**TOWN OF BAY HARBOR ISLANDS
PLANNING AND ZONING BOARD**

May 5, 2015

AGENDA ITEM REPORT

ITEM: Request for approval of a revision for "Mitchell Eichen and Annette Samson-Eichen" located at 10340 W. Broadview Drive, Lot 33 of Block 23. The submitted construction plans have been modified after approval from Planning and Zoning. A roof terrace has been added and the location of some windows has changed slightly. Enclosed please find the site plan and elevations (Item #1A)

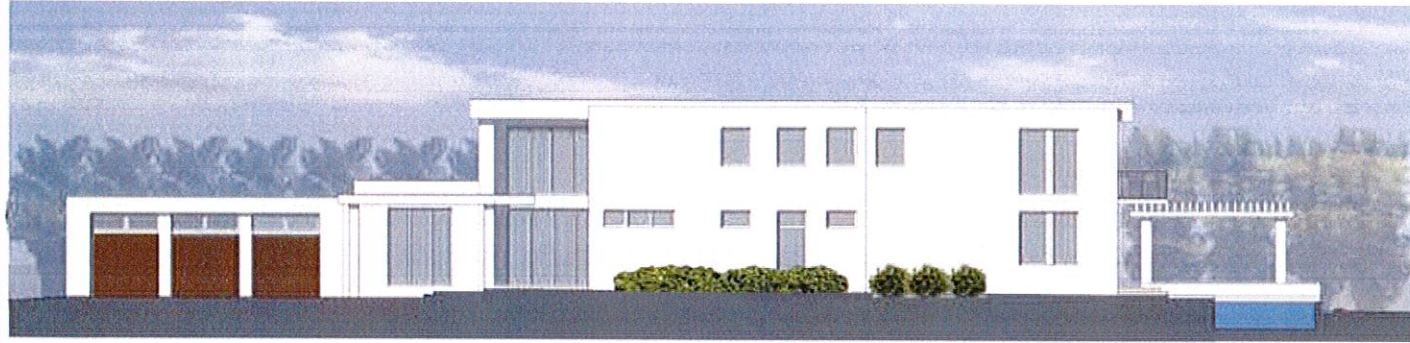
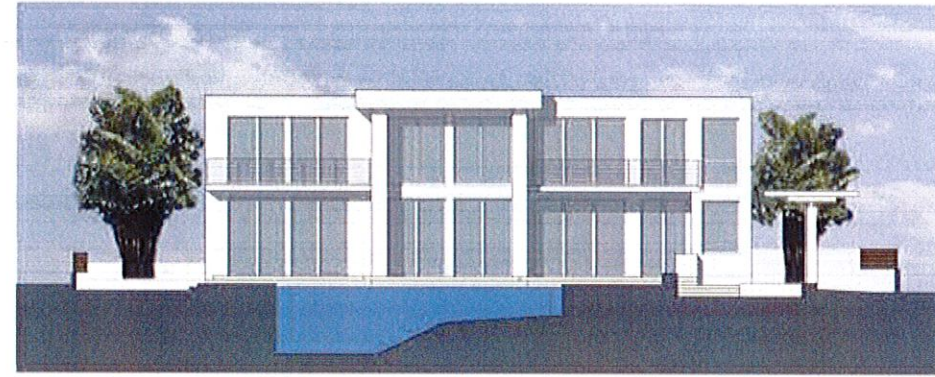
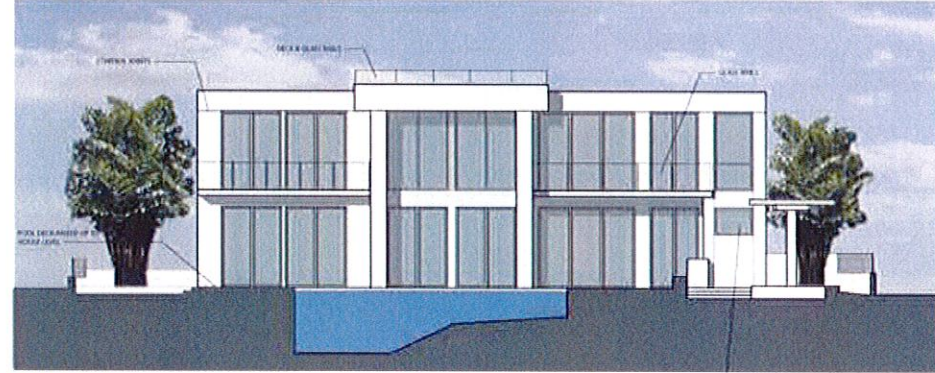
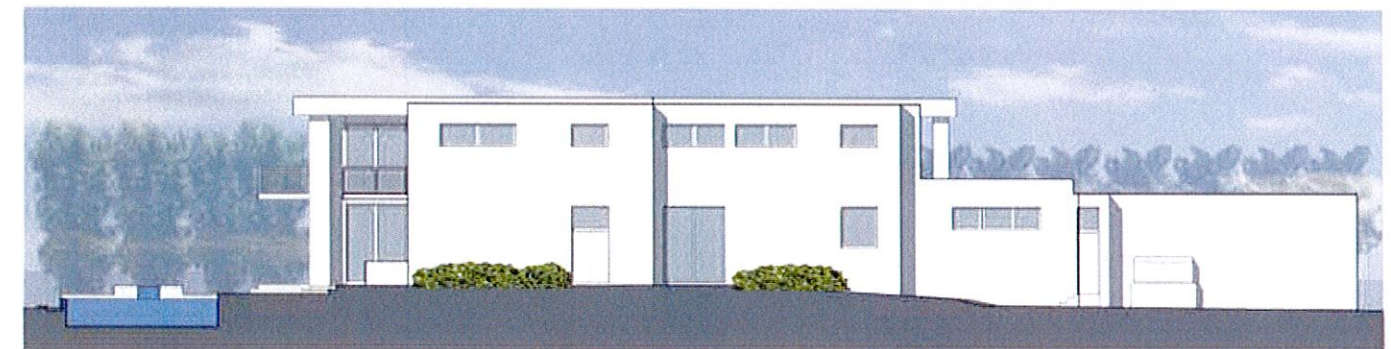
- 3) On the West Elevation, some windows placements were changed (kitchen / exercise room), exterior stairs were added to access the roof terrace, railing materials were changed and louvers for the garage were added on the BP plans that were not shown on the PZB approved plans. **PZB approval is being requested for the changes to the West Elevation.**

SOUTH ELEVATION AT STREET
APPROVED

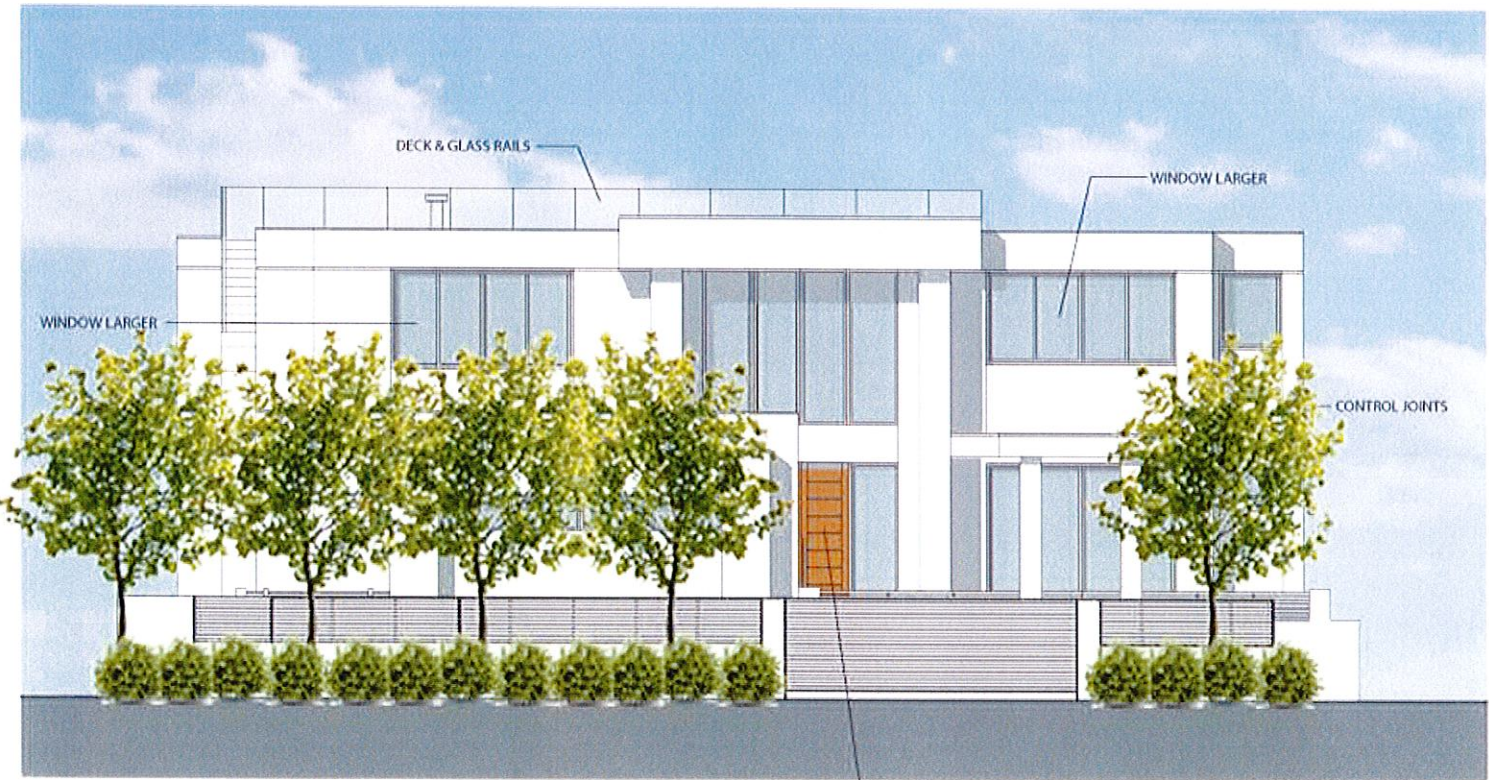
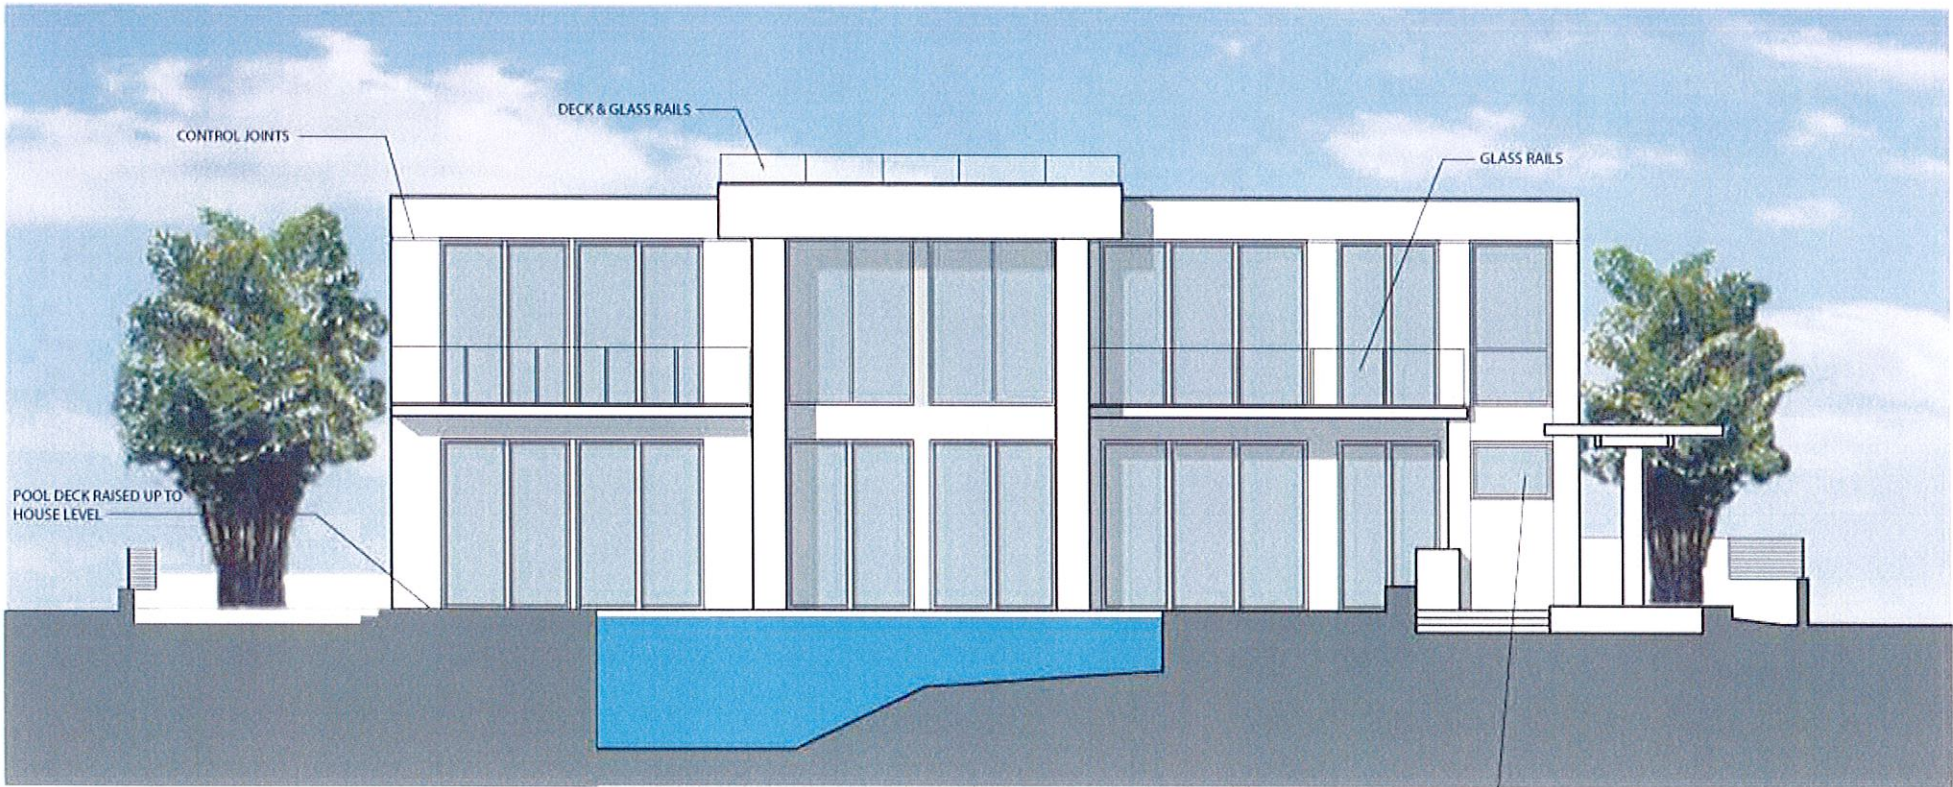
- 4) The East Elevation of the BP plans show a window that differs (media room) from the PZB approved plans as well as a change in the garage door material. **PZB approval is being requested for the changes to the East Elevation.**
- 5) The North Elevation of the BP plans show a window that differs (pool bath) from the PZB approved plans as well as the railing material. **PZB approval is being requested for the changes to the North Elevation.**
- 6) The South Elevation of the BP plans show the second floor windows larger than the PZB approved plans. The front door and the color of the aluminum portion of the front fence has also changed. **PZB approval is being requested for the changes to the South Elevation.**
